**ADDENDUM #001
ITB 5742-2023
Gilchrist Elementary School Millwork Replacement Project**

Date: May 23, 2023

Gilchrist Elementary School Casework Replacement For Leon County Schools

Interior Elevations
DRAWING NAME
Casework Elevations

8 Casework Sections
SCALE: 3/4\"/>

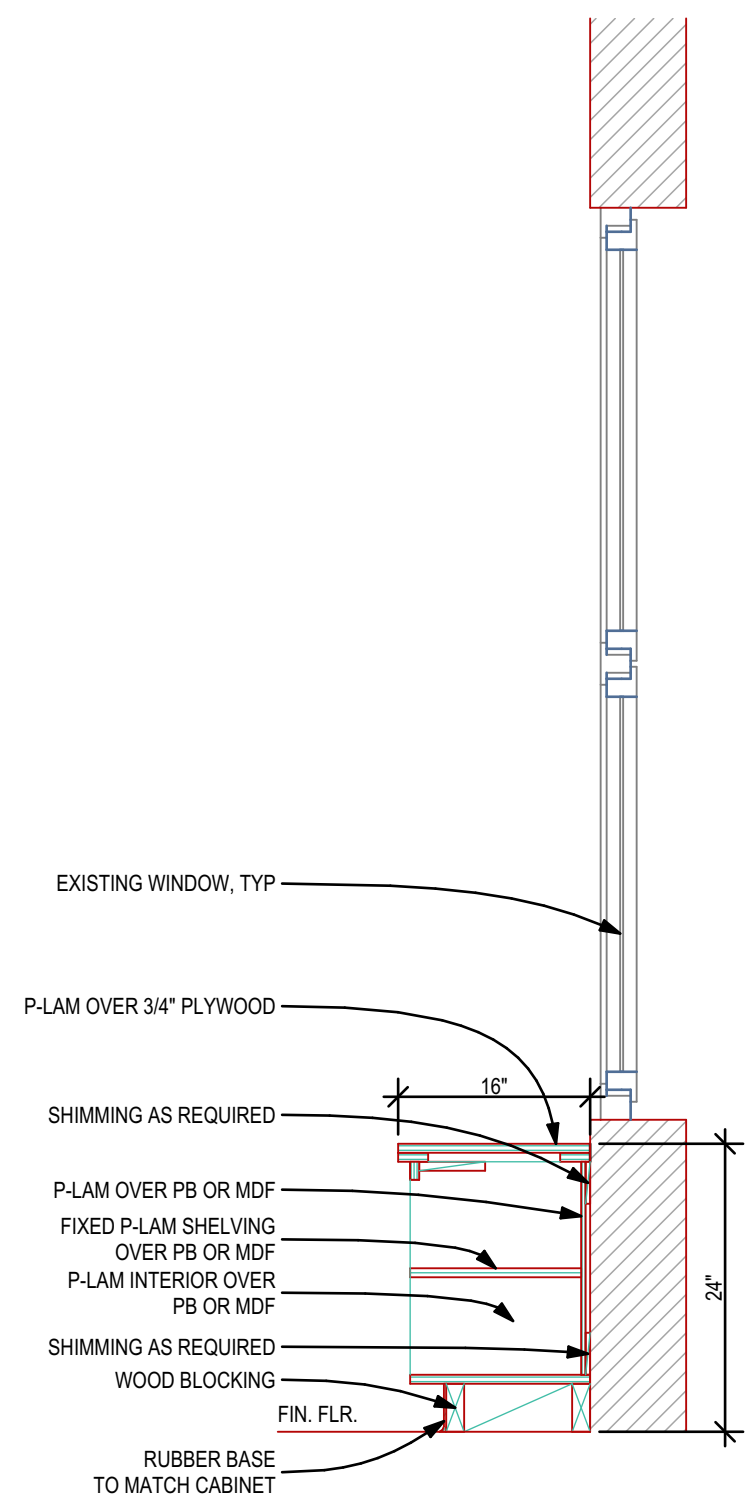
Answer:	The scope is correct.
2.	Upper cabinets shown in plans are 24" deep, is this correct? Typically upper cabinets are only 12" deep.
Answer:	Please see the revisions to the plans (Revised Sheet A7.2) in this Addendum #001.

Sheet A7.2 of the Exhibit 1 is deleted in its entirety and replaced with Revised Sheet A7.2, attached to this addendum.
